PoE SHIELD

ONsemi PoE Shield			
Title	<DK>		
Size	Document Number	Rev	
A3	<Doc>	<A>	
Date:	Friday, November 25, 2016	Sheet	1 of 2

PoE W5100 SHIELD

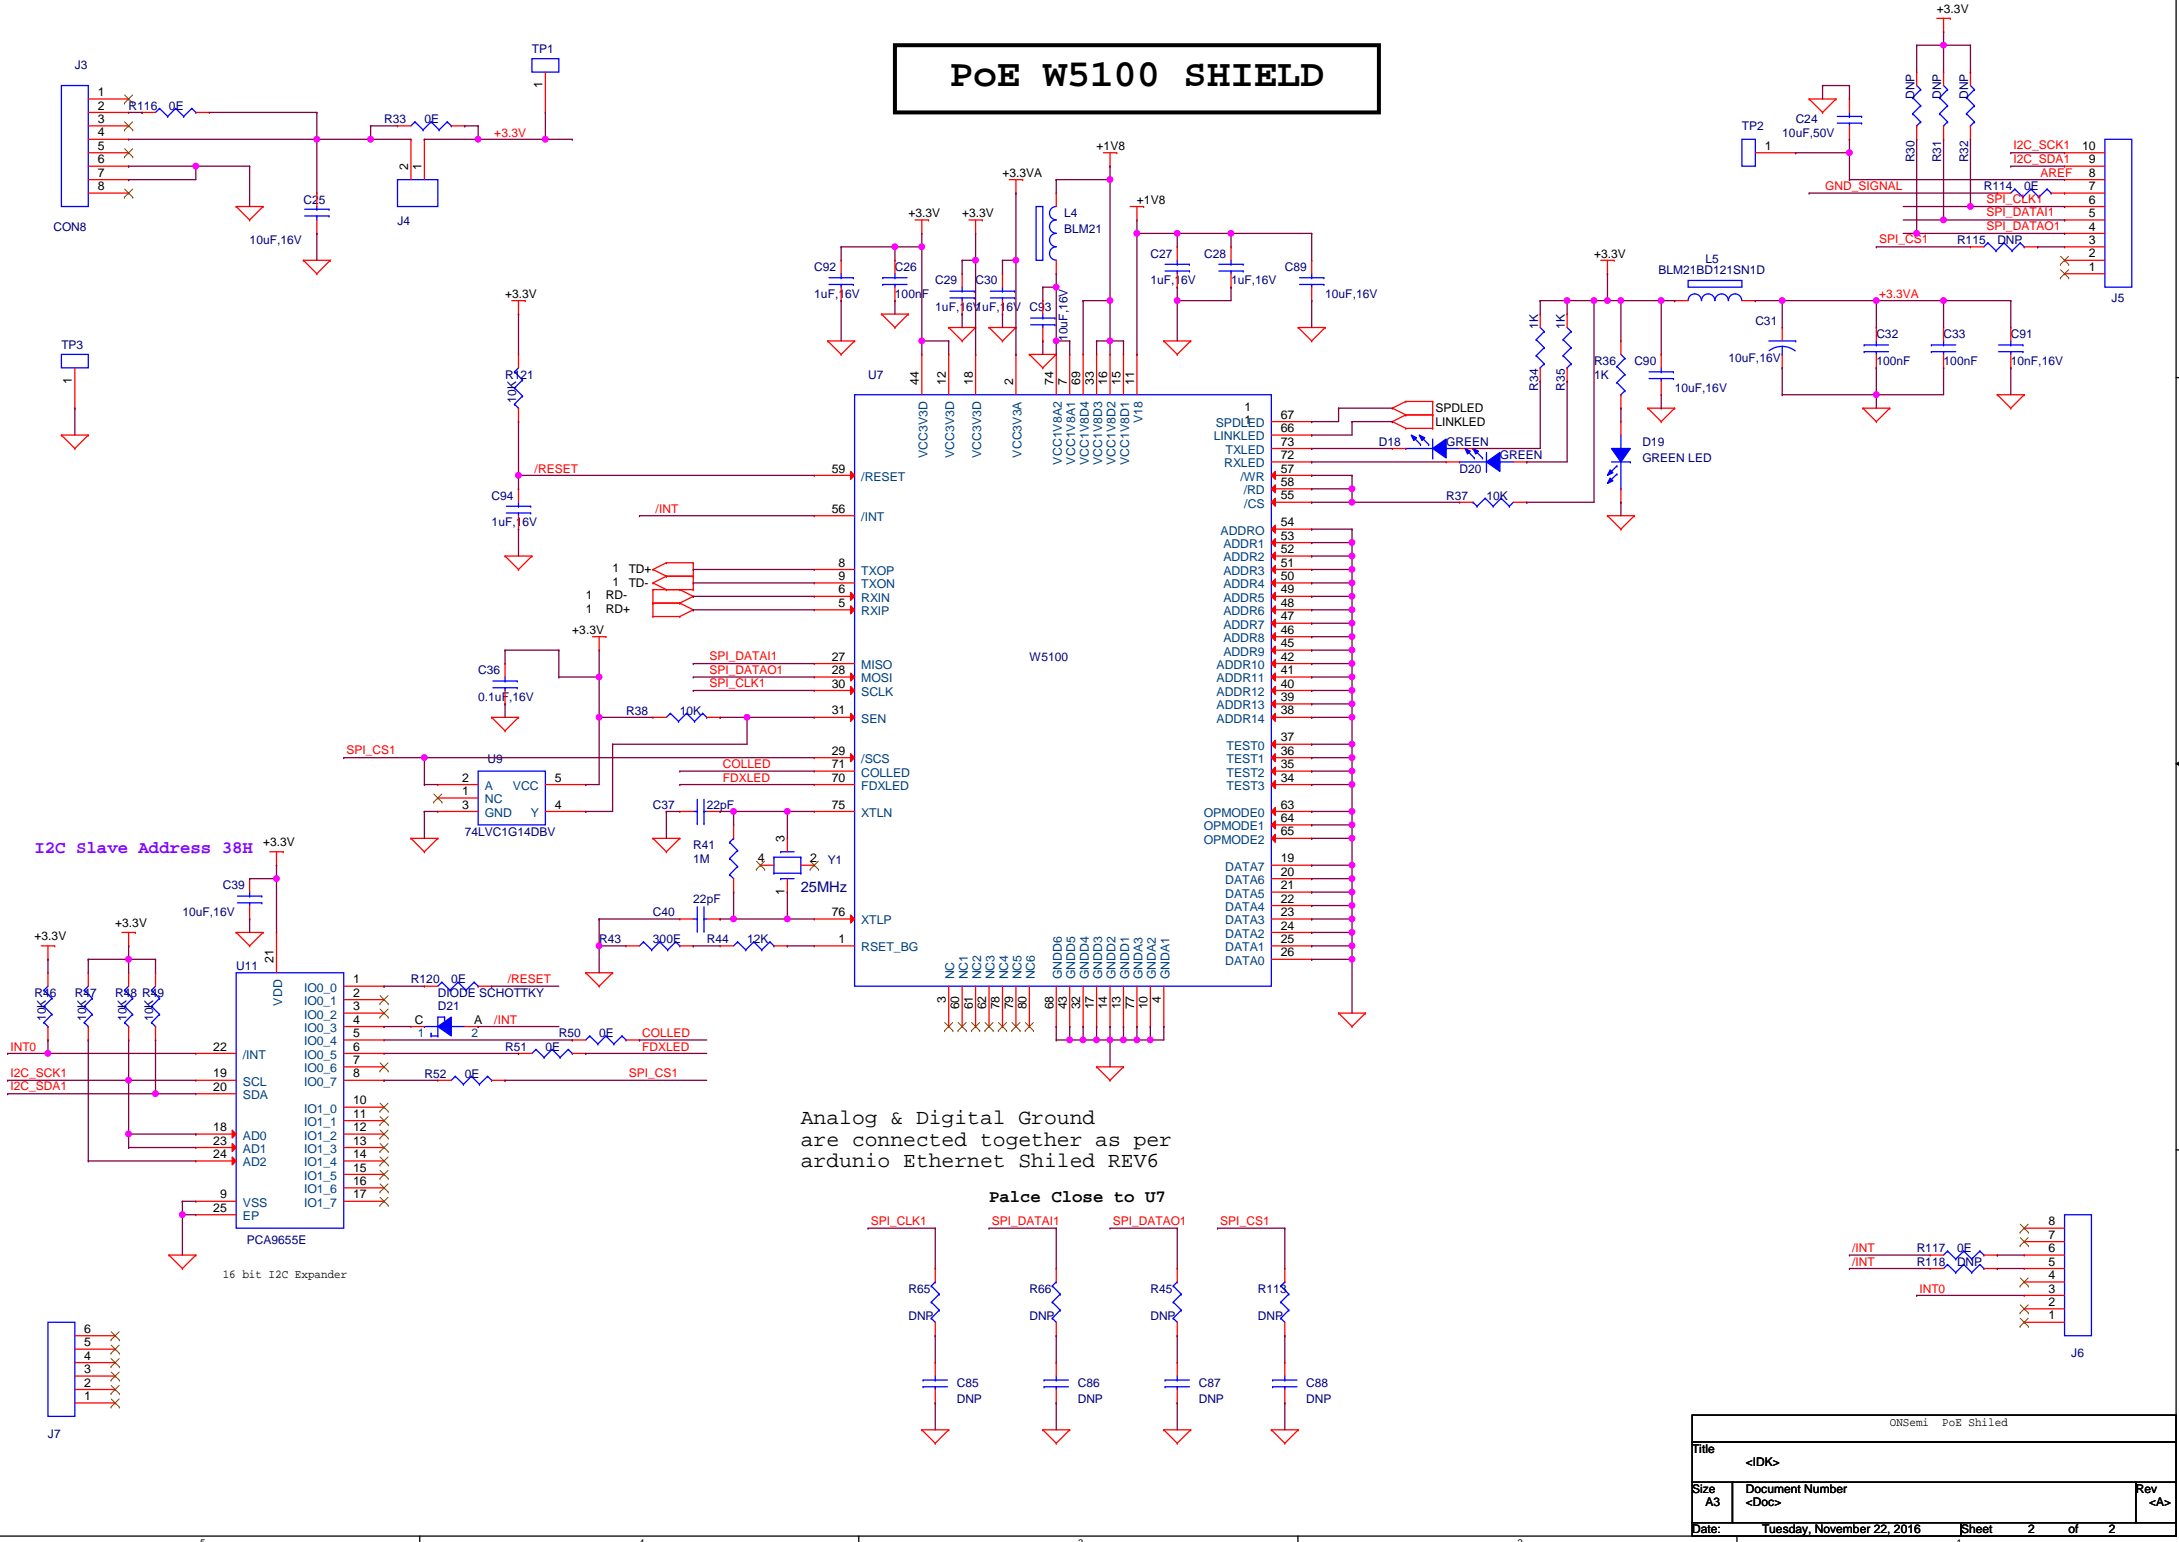
The Pin Naming & Connections follows the datasheet conventions of 749012013

The Pin Naming followed is wrt PD side convention.

Do FB pin 19 needed to grounded?
